STANDARD DEPARTURE CHART-INSTRUMENT

RJFN / NYUTABARU

NIPPO SEVEN DEPARTURE

SAITO ONE DEPARTURE

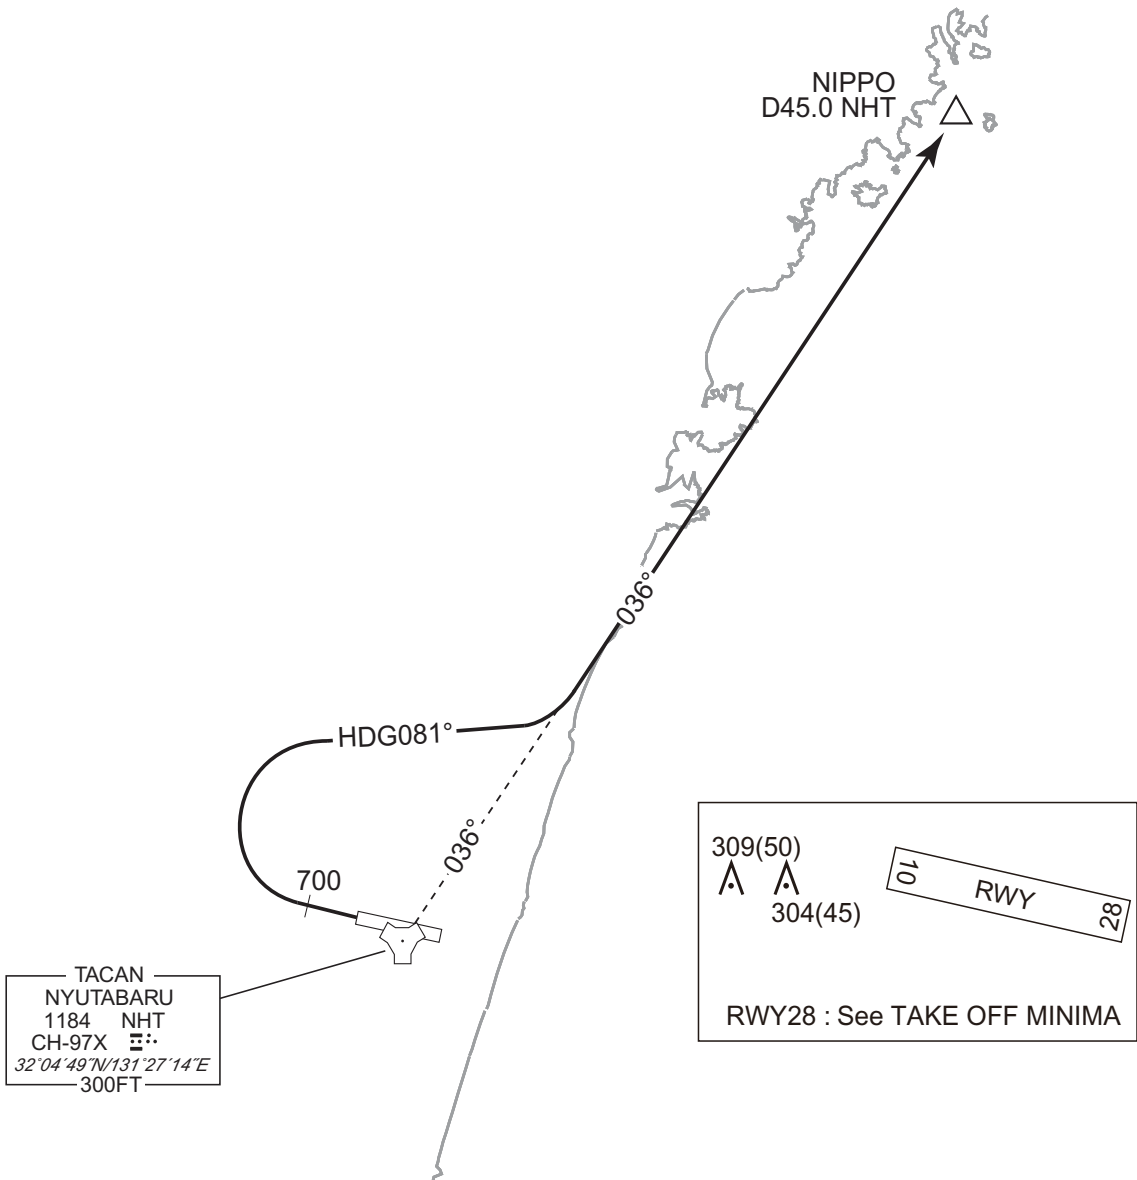
CHANGE : New PROC.

TENSO ARRIVAL

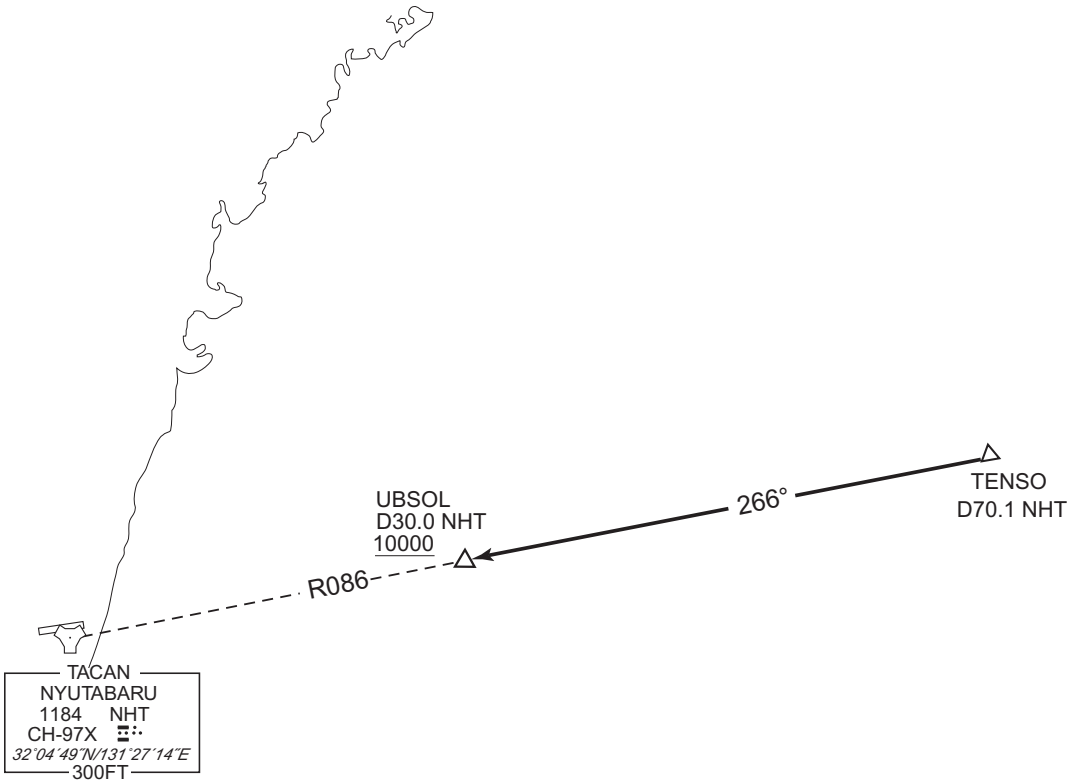
CHANGE : PROC course. UBSOL established. ALT restriction.

TACAN Z RWY28

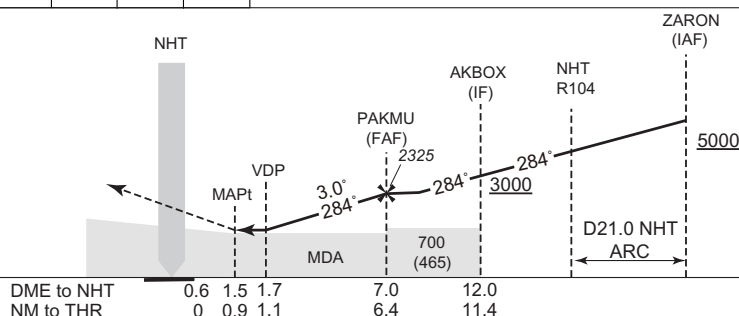
CHANGE : PROC course. Missed APCH course. MINIMA. PAKMU,AKBOX established. NM to THR. ALT(3.0°APCH Path), DME to NHT added.
Missed APCH climb gradient MNM added. VAR.

RJFN / NYUTABARU

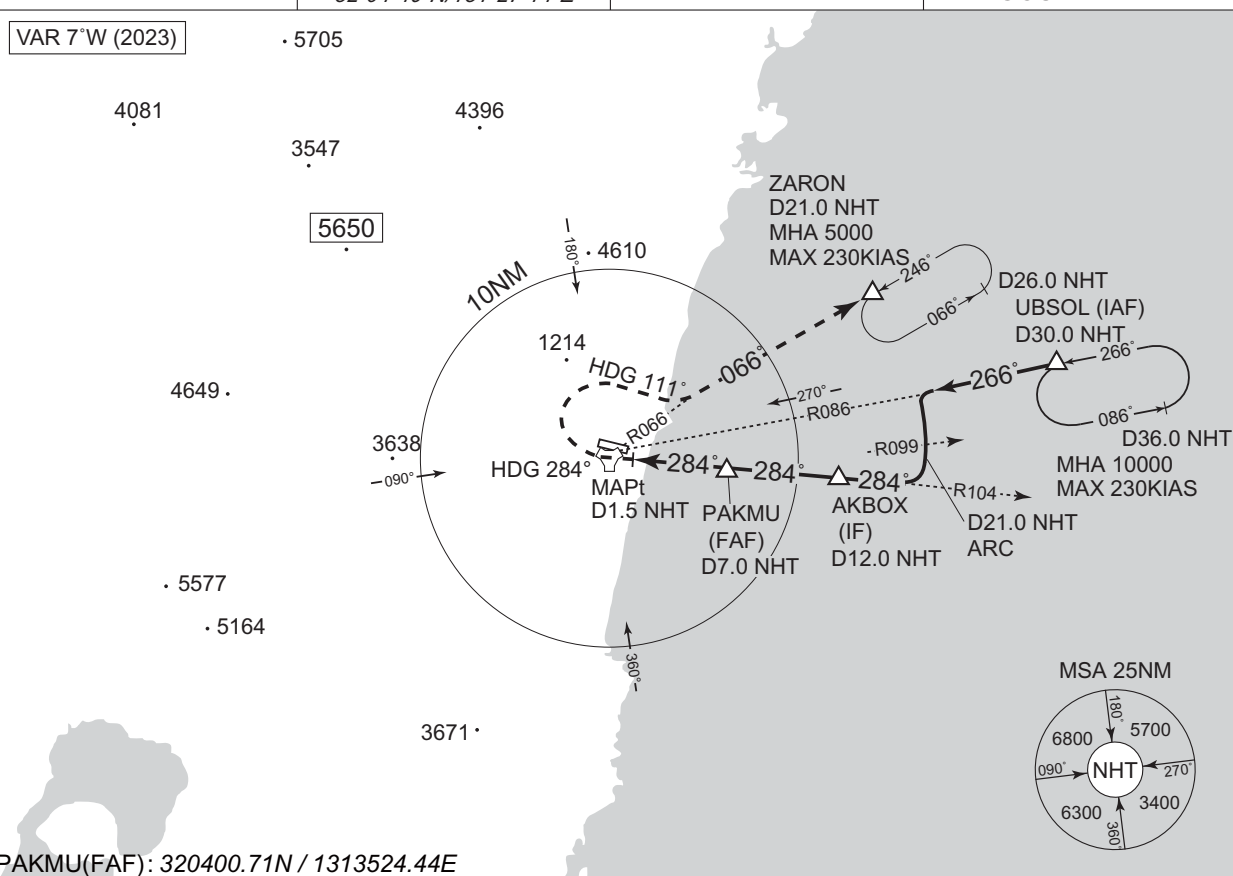
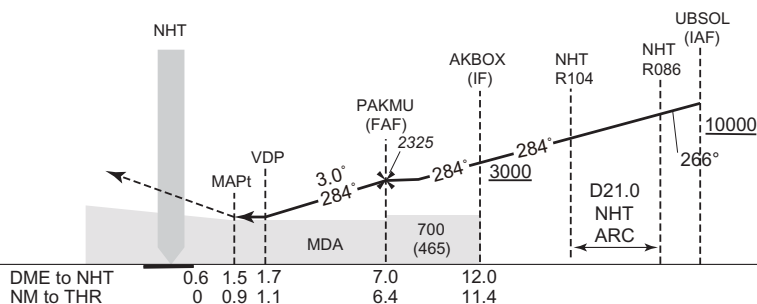
CHANGE : PROC course. Missed APCH course. MINIMA. UBSOL, PAKMU, AKBOX established. NM to THR. ALT(3.0°APCH Path), DME to NHT added.
Missed APCH climb gradient MNM added. VAR.
